Product Change Notification

1. ECN #: 285091

- IPBS - .165 DOUBLE ROW SOCKET ASSEMBLY

Existing product with -GP option

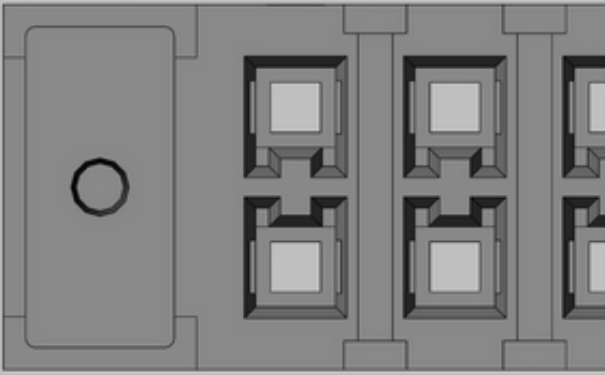
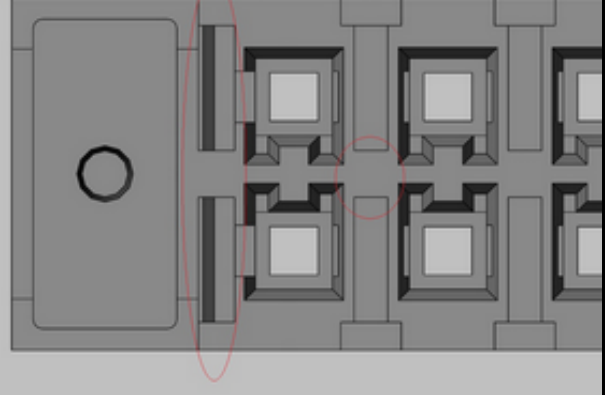
Add void corings on 06 through 15 positions body.

Visual inspection; voids will be noticed on ends of body where prior revisions had no voids; this is a rolling change.

Changes made to improve dimensional consistency.

- Form - this is a Form change.
